Final Product/Process Change Notification

Document #:FPCN23449XB

Title of Change:	Assembly and Test Transfer from AUK Dalian, China to JCET CHUZHOU, China for TO92 Products, Case Outline 29-11 Change for TO92 Products.
Proposed First Ship date:	20 Mar 2022 or earlier if approved by customer
Contact Information:	Contact your local onsemi Sales Office or Jireh.Dulla@onsemi.com
PCN Samples Contact:	Contact your local onsemi Sales Office or PCN.Support@onsemi.com Sample requests are to be submitted no later than 30 days from the date of first notification, Initial PCN or Final PCN, for this change. Samples delivery timing will be subject to request date, sample quantity and special customer packing/label requirements.
Additional Reliability Data:	Contact your local onsemi Sales Office or Lalan.Ortega@onsemi.com
Type of Notification:	This is a Final Product/Process Change Notification (FPCN) sent to customers. FPCNs are issued 90 days prior to implementation of the change. onsemi will consider this change accepted, unless an inquiry is made in writing within 30 days of delivery of this notice. To do so, contact PCN.Support@onsemi.com

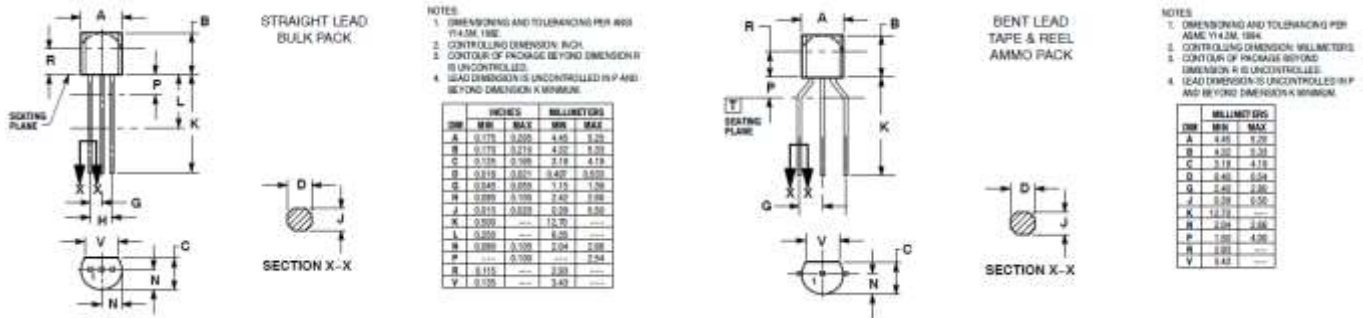
Description and Purpose:

onsemi would like to inform customers of the intent to transfer assembly and test for the TO92 products listed in this notification from the current site, AUK Dalian, China to JCET CHUZHOU, China. BOM (Bill of Materials) changes are listed below:

Before Change Description	After Change Description
LeadFrame	KDMM-B005(95X95 MIL C/G TO-92 AUK)	LF TO92L 3L CuAg STAMPED
Die Attach	ABLE843-001(EPOXY ABLE STICK)	ABLEBOND 84-3J
Mold Compound	7EMC1040(HFMOLD COMPOUND EME-E120G)	EMG-460-3
Assembly Site	AUKD	JCET China

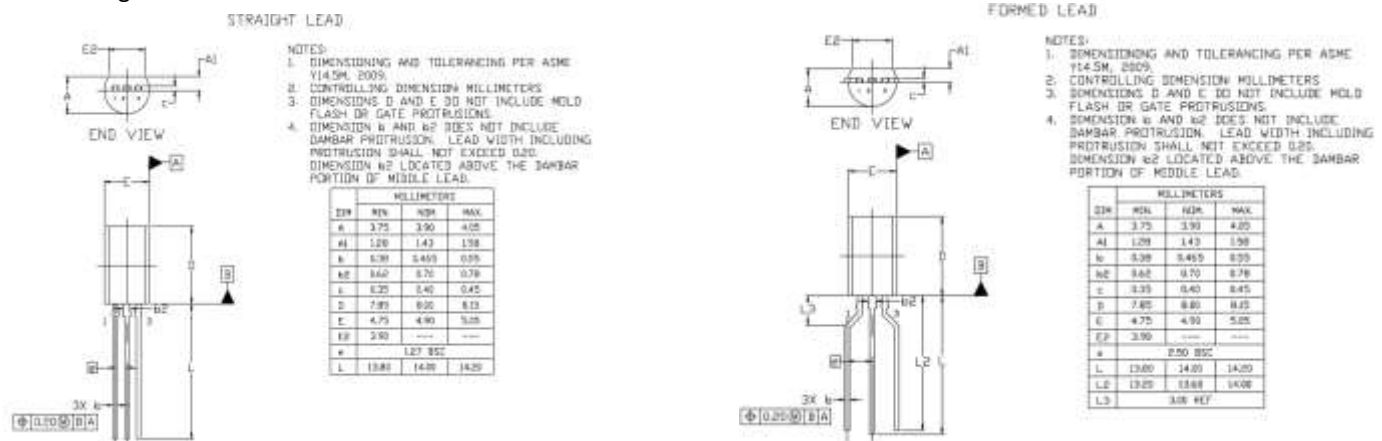
Product marking changes are shown here:

From	To
Product marking change	Trace Code Assembly Location Line 3: W(LYW) L: Wafer Lot Number YW: Assembly Start Week	Trace Code Assembly Location Line 3: JC(LYW) L: Wafer Lot Number YW: Assembly Start Week Note: No Pb Free Microdot

Before Change:

After Change:
